SUBJECT: 072112 PCT STRAD BAY ROOF AND HUSKY MAINTENANCE TOWER ROOF REPLACEMENTS

Responses to Bid Questions # 03

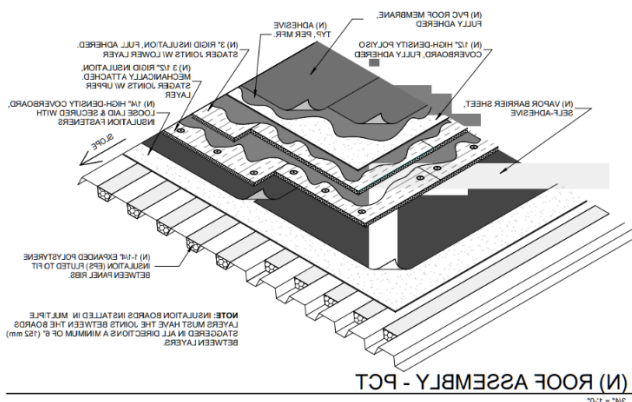
- 1) will get you an e mail from my rep stating that Duro-Last meets or exceeds the proposed product.
- 2) Will the roofing be removed on either building or not?
- 3) At the bid walk we were told it won't, but the plans are saying it will.
- 4) I see décor ribs are to be installed. What is the purpose of this? These roofs are not visible from the ground.

- 5) what is the purpose of raising the ladder? Does it mean temporarily raise it to change the coping metal?
- 6) Why are we using fleece backed material? This costs more and has no benefit. This is usually used when glueing over torch down roofing.

1. The demolition at the PCT Strad Bay roof area consists of the removal and disposal of the existing standing seam metal roofing panels. Expanded Polystyrene (EPS) Insulation will be fluted to fit into the underlying metal deck ribs, per Detail 2 on Sheet A1.10. See Details 3 & 8 on Sheet AD9.10 to reference metal roof panels to be demolished. See Detail 5 & 6 on Sheet AD9.10 to reference underlying metal deck to be fluted with EPS insulation (as viewed from the bottom).

2. Demolition of the roofing panels is not part of the scope of work at Husky.
3. Contract documents take precedence over any discussions held during the pre-bid walk unless formally modified in writing through addendum.

4. Decor ribs have been removed from the scope of work per Addendum No. 1.
5. The Roof Access Ladder at PCT will be permanently raised to accommodate depth of the new roofing assembly. Refer to details 8/AD9.10 and 10/A5.10.

6. See revisions to paragraph 2.02-A in specification 07 53 00 – Single Ply Membrane Roofing (PVC) to be issued in Addendum #02. Fleeceback membrane is not required for any portion of this project. Submit substitution requests in accordance with Section 00 26 00 – Substitution Procedures.

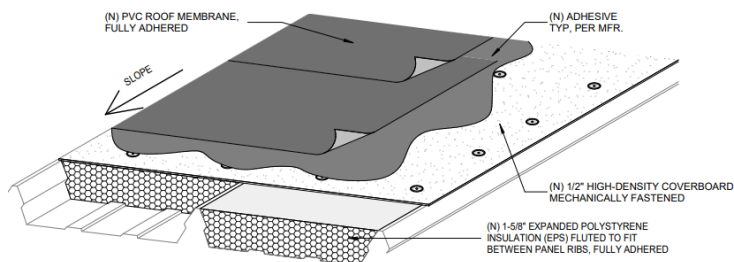
There are conflicting drawings. On A1.10 I see the roof assembly for PCT described as shown here.

Roof assemblies are not conflicting, they are different for each building – refer to the drawings. PCT roof details are shown on drawing sheet A5.10, with Husky roof details on sheet A5.20. There are no parapet walls on the structure, ladder modifications are required to suit the depth of the new roof assembly at PCT per detail 10/A5.10.

(N) ROOF ASSEMBLY - HUSKY

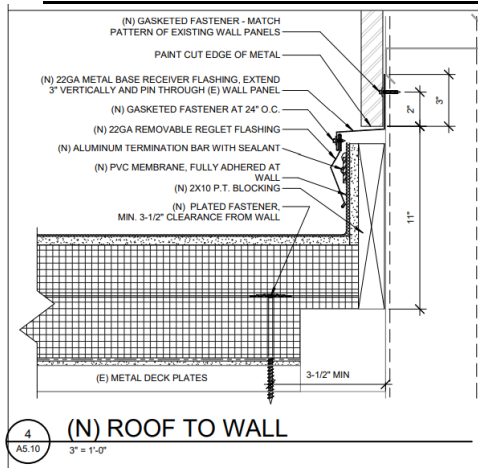
And on A1.20 I see Husky showing as this.

And then on A5.10 it shows this.

Please clarify this. Also need to know why we are installing insulation on the parapet wall and cutting the ladder to extend it. This is not necessary. Please advise.
